ADDENDUM NO. 10

February 15, 2010

Project: **Package C – 2009: Holbrook Elementary School Renovations**
 Cypress-Fairbanks Independent School District

Bay Project No.: 0840 (10-01-2069R-FP)

REVISED ENLARGED PLAN 3/AT2.01

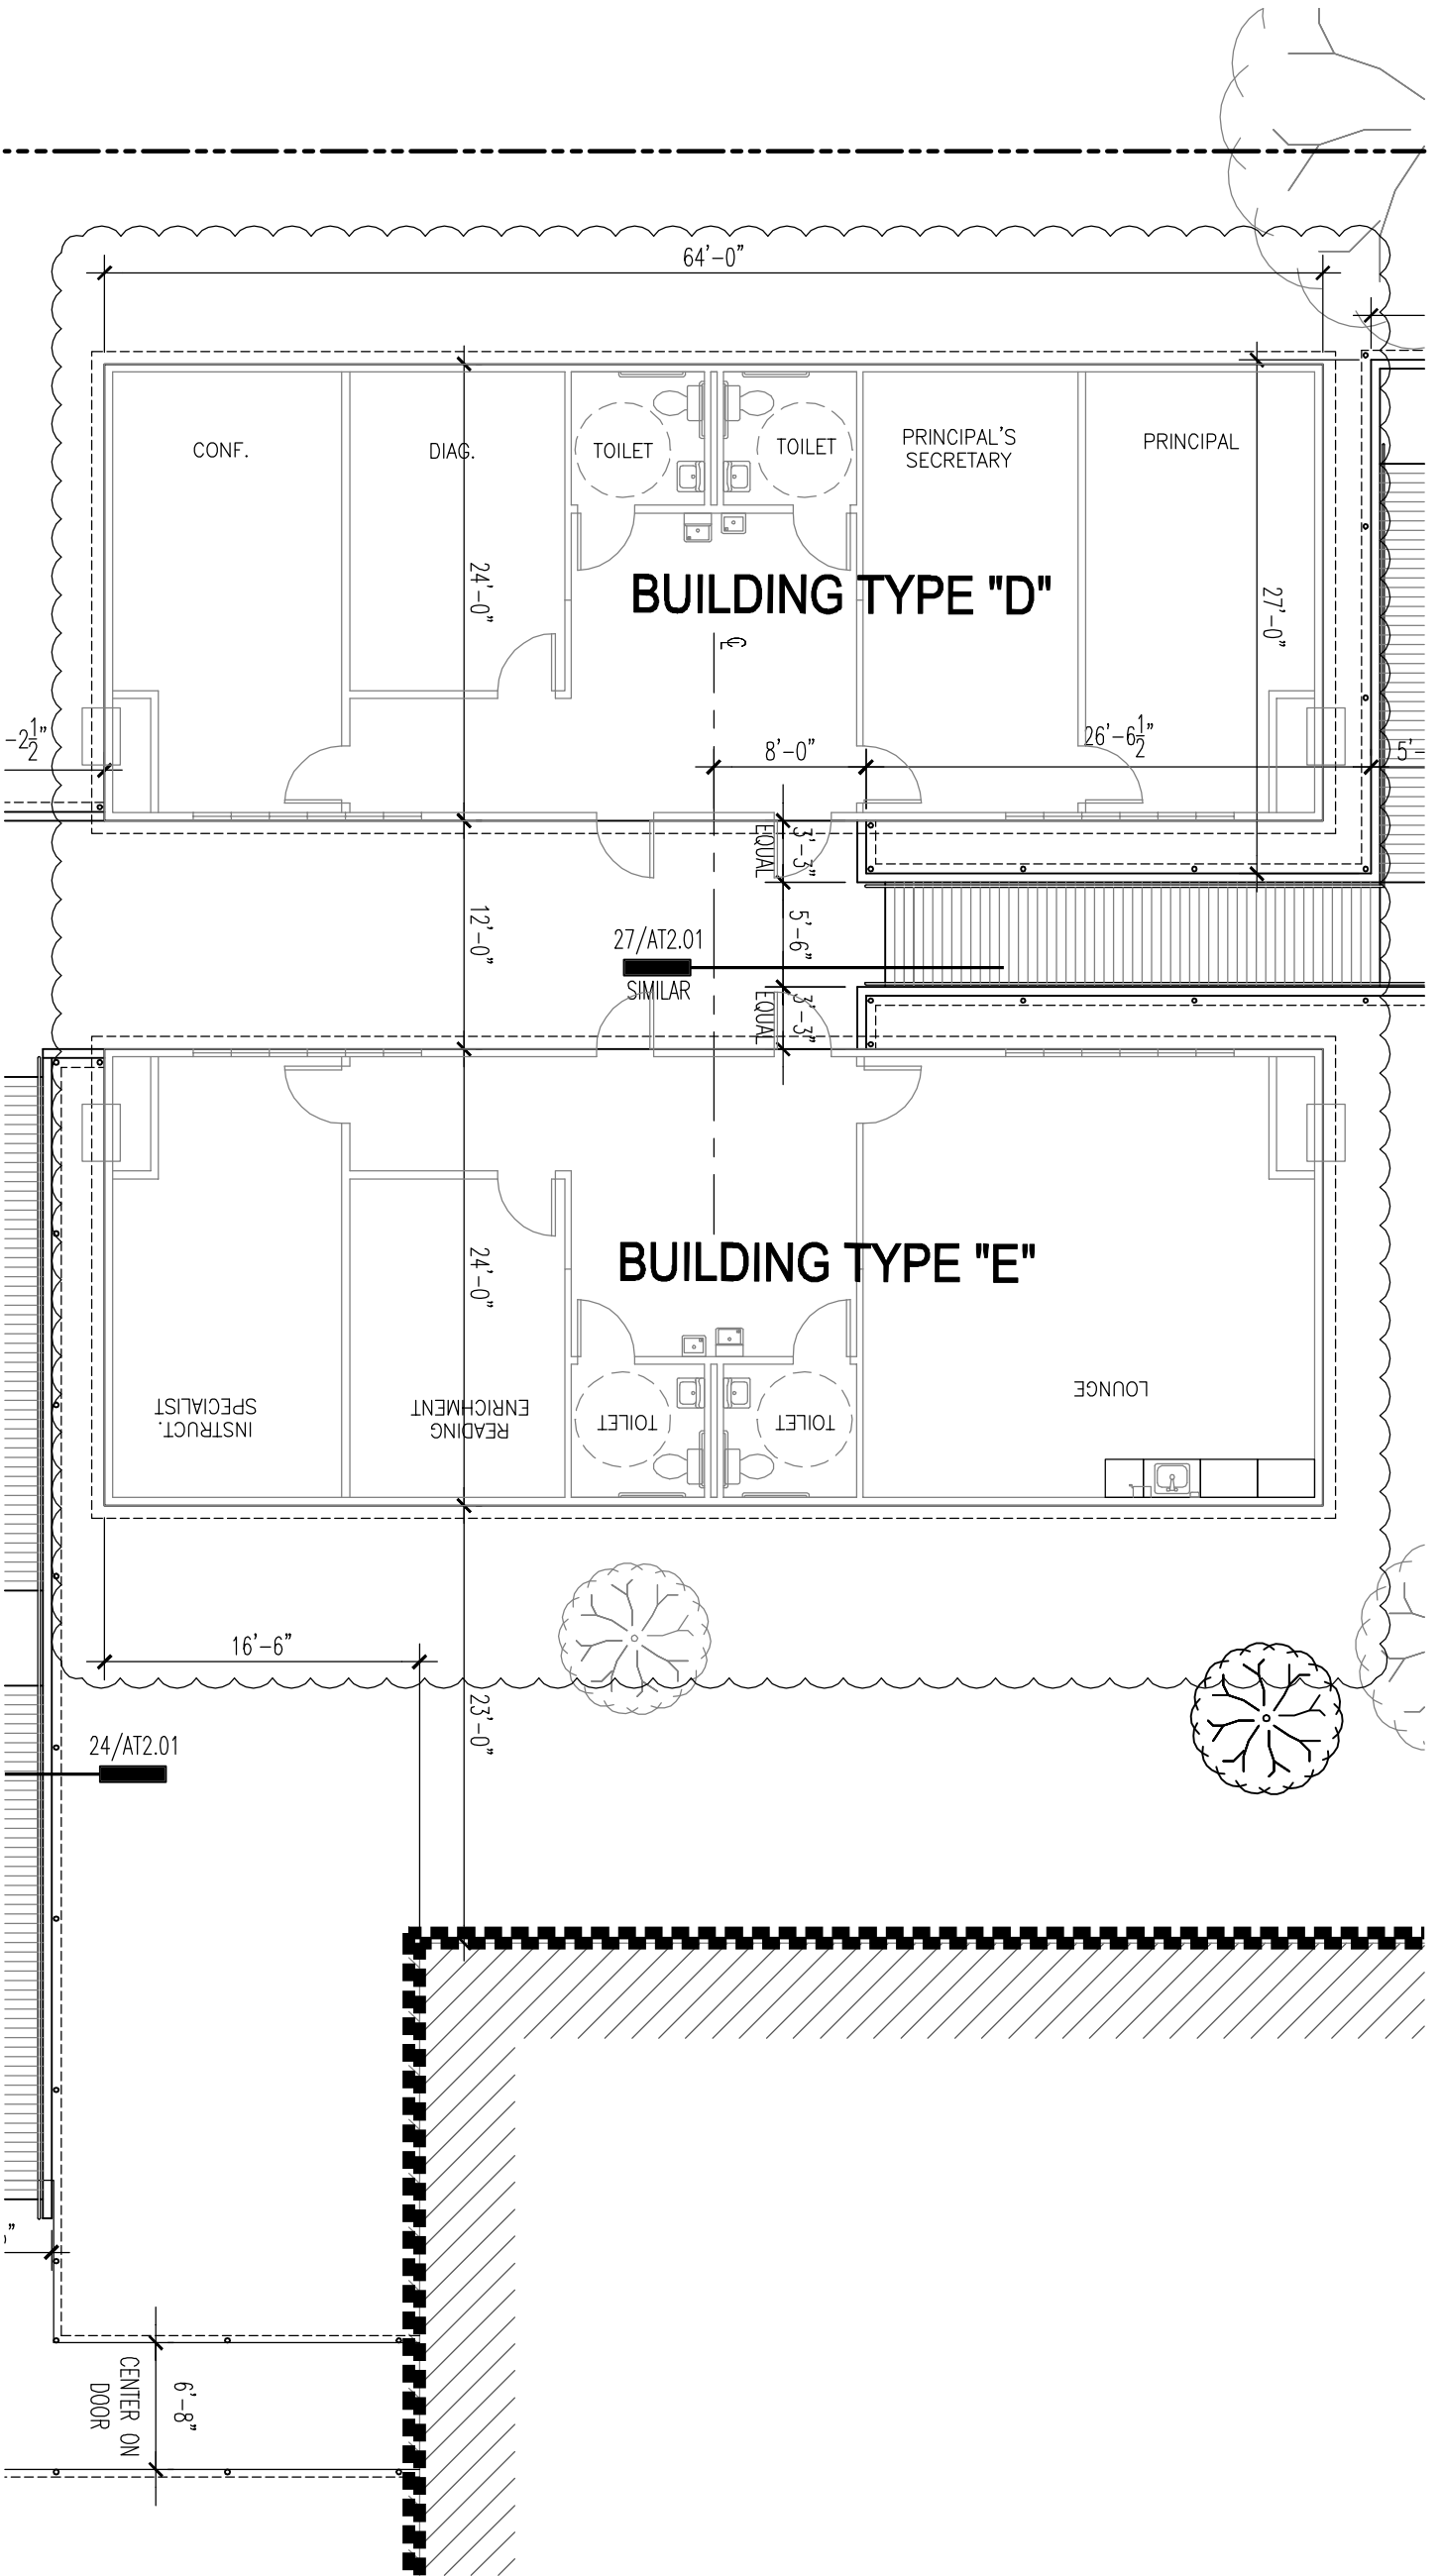
07. Sheet AT2.01 Portable Building Enlarged Plans and Details
 - a. Portable Building Types denoted; revise Detail 3 as indicated on the attached sketch ADD 10 SK.01

ADDED NEW ENLARGED PLAN - PORTABLE BLDG TYPE D - 21/AT2.02

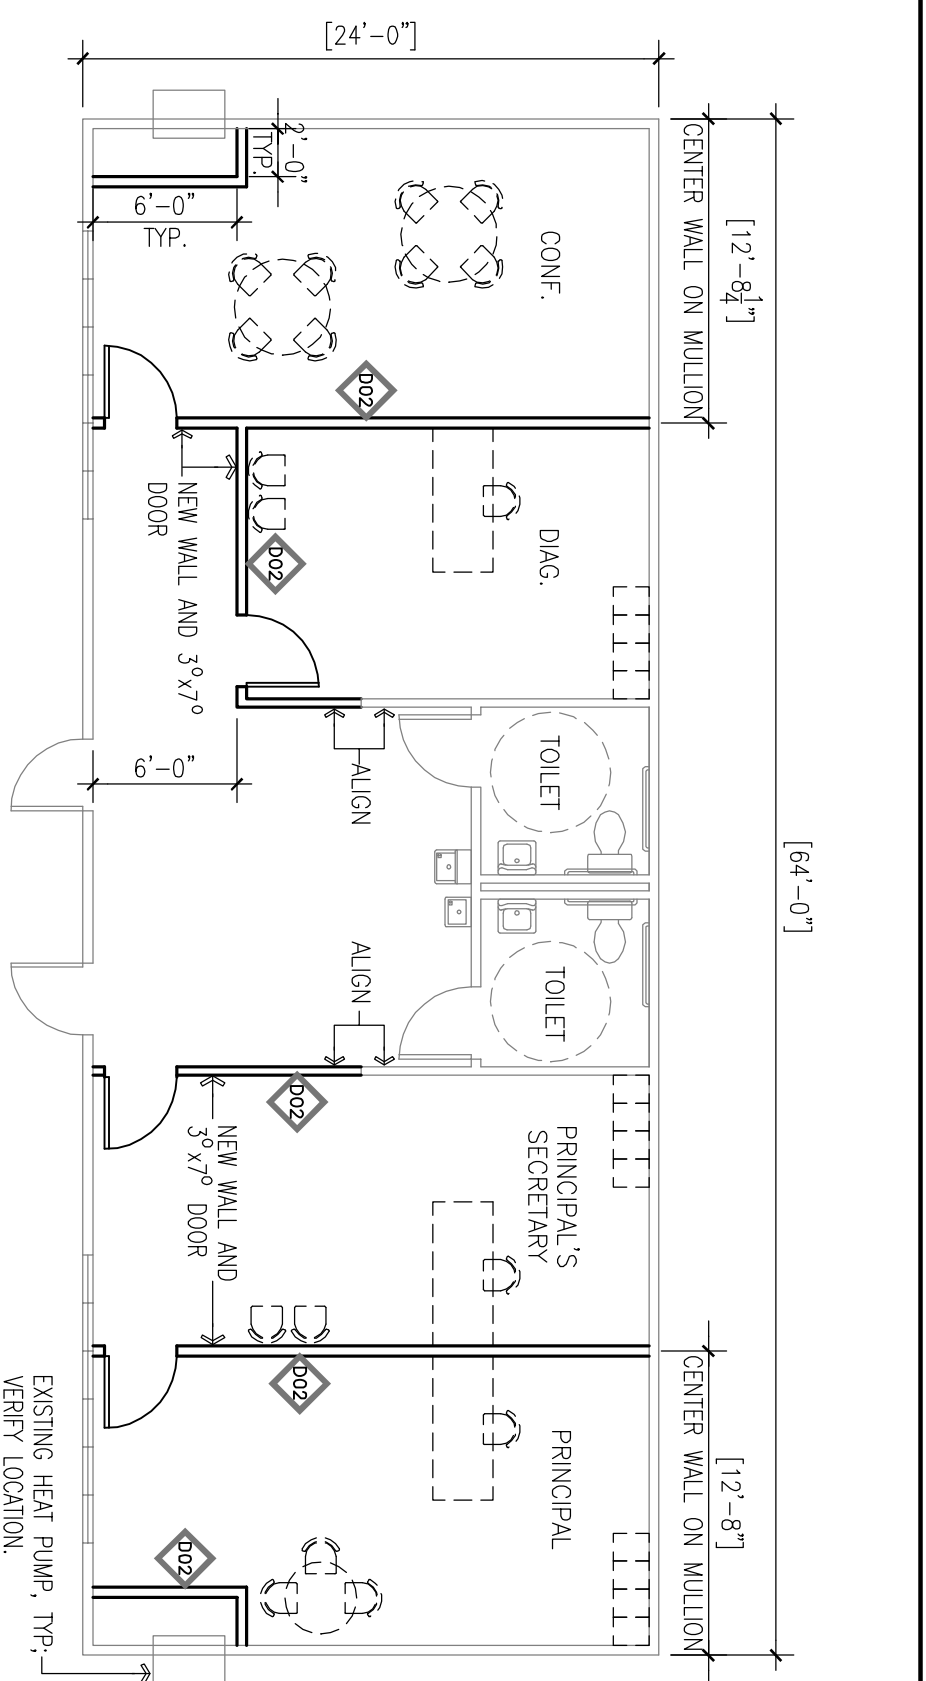
08. Sheet AT2.02 Portable Building Enlarged Plans
 - a. Add details 21 and 27 Layouts for Portable Buildings Types D and E per the attached sketches ADD 10-SK.02 and ADD 10-SK.03

Sill Dimension and additional noting at 1/A9.00

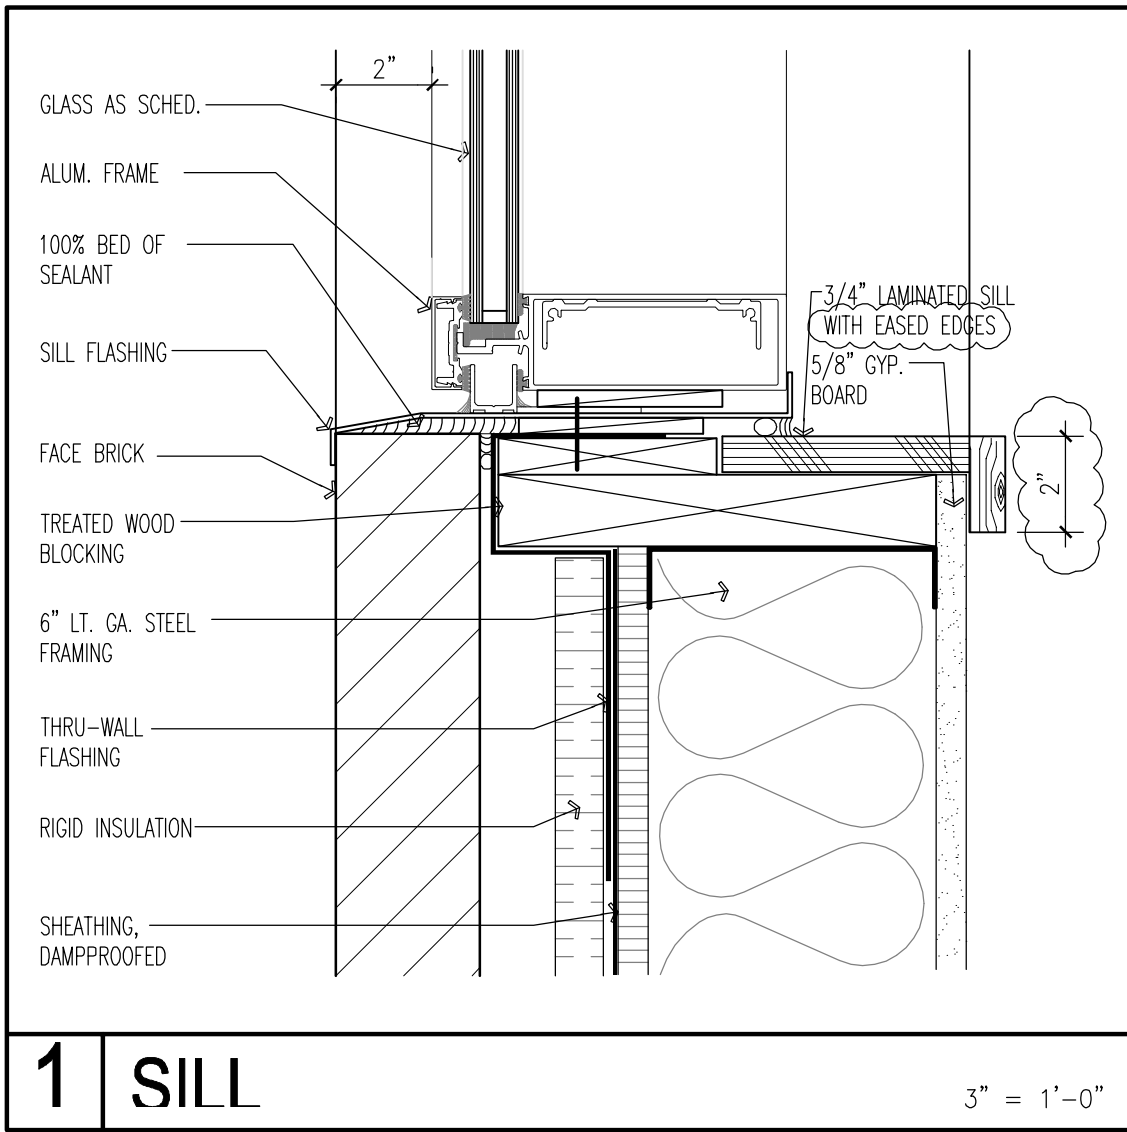
12. Sheet A9.00 Door/Window Frame Elevations
 - a. Revise details 1, 5, 9, 11, 15, 17, 23, 24 per the attached sketches ADD 10-SK.04 thru ADD 10-AK.11.
1. Sheet MEP1.0

PORTABLE BUILDINGS MECHANICAL FLOOR PLAN

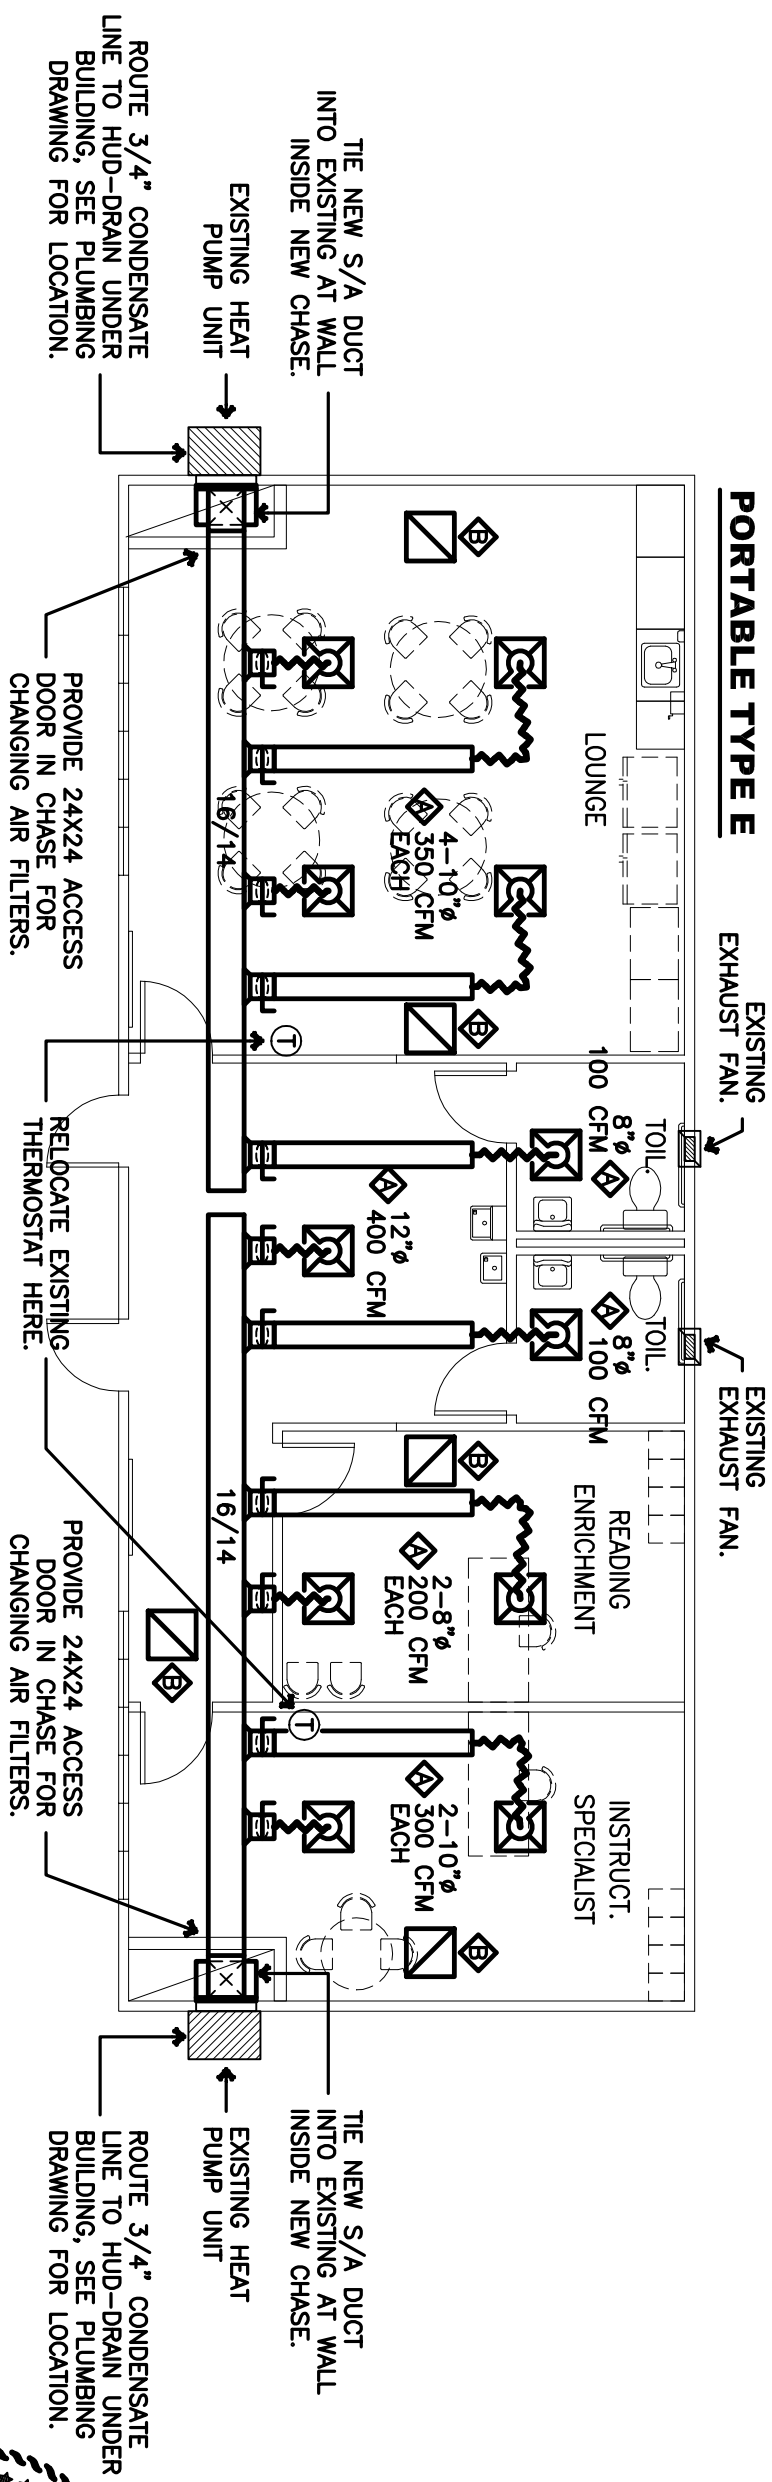
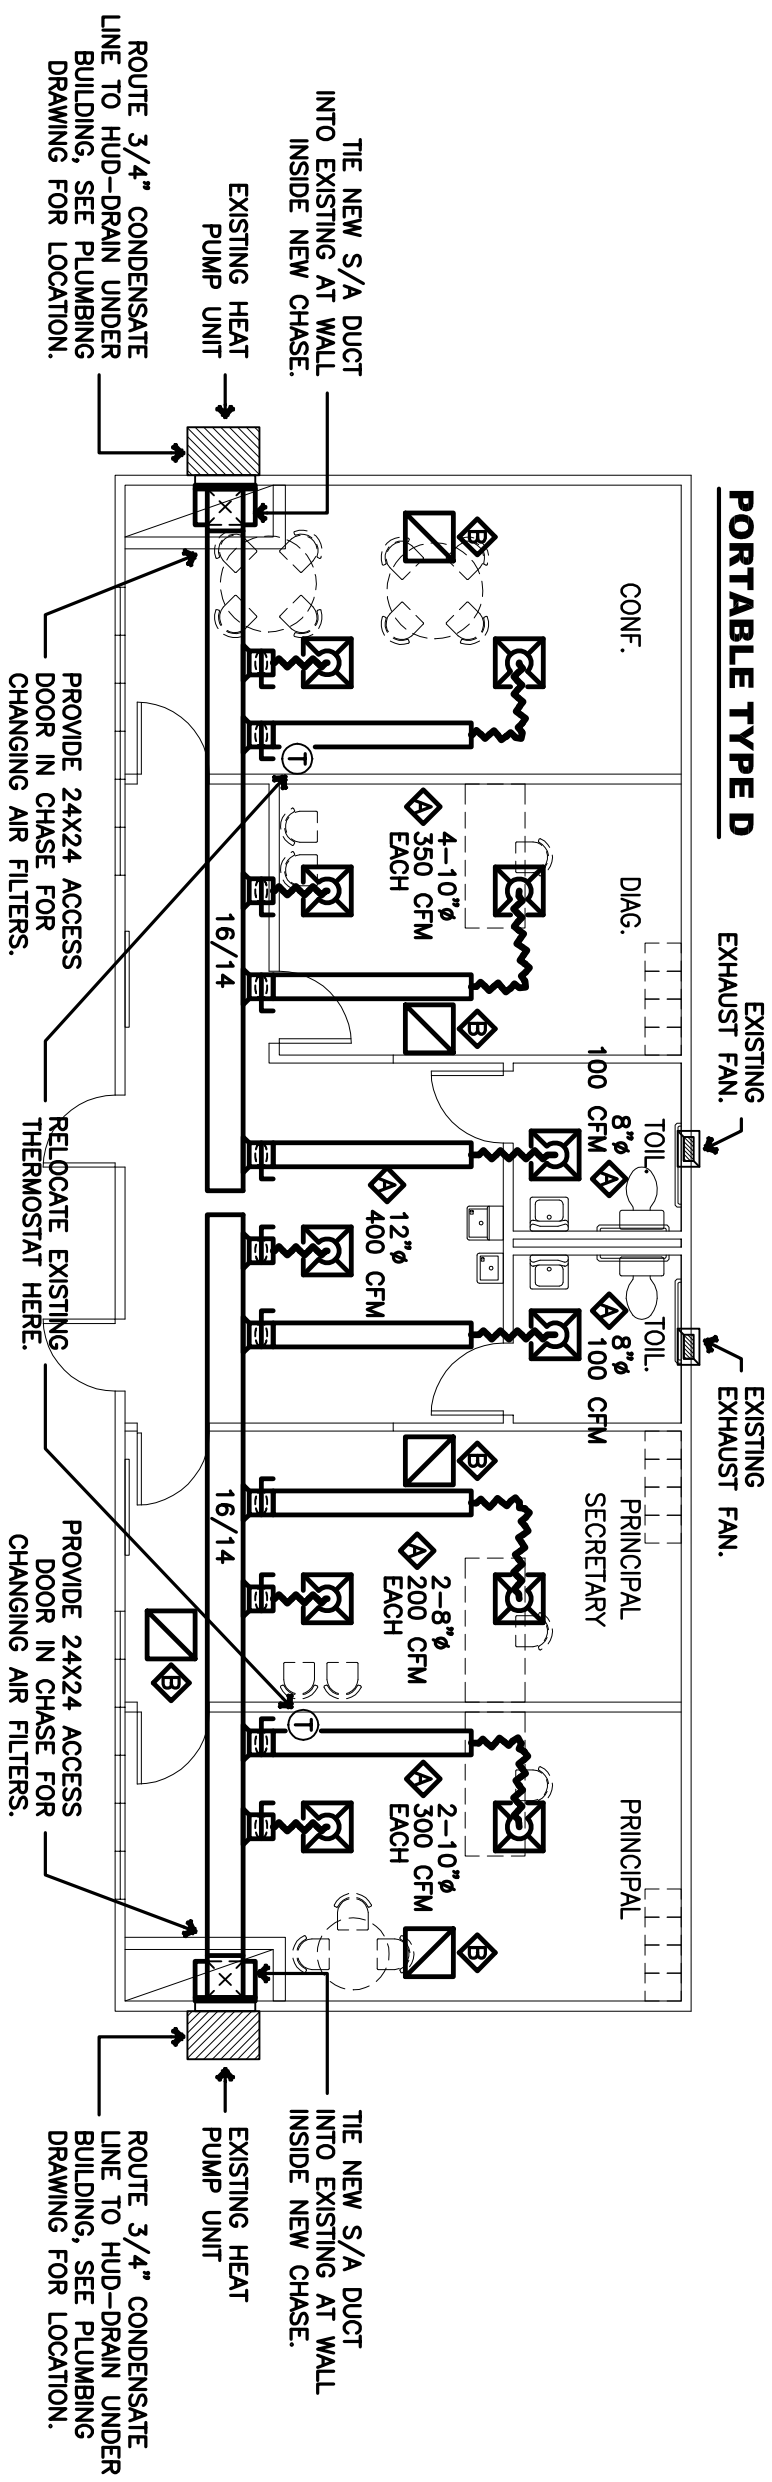
- a. See attached Sheets ADD10-SKE1 & ADD10-SKE2 for lights and security cameras at T-Bldgs.
2. Sheet M1.1 – Mechanical Floor Plan – Area A
 - a. Mechanical for Portable Buildings shall be per attached Sheets ADD10-SKM1.
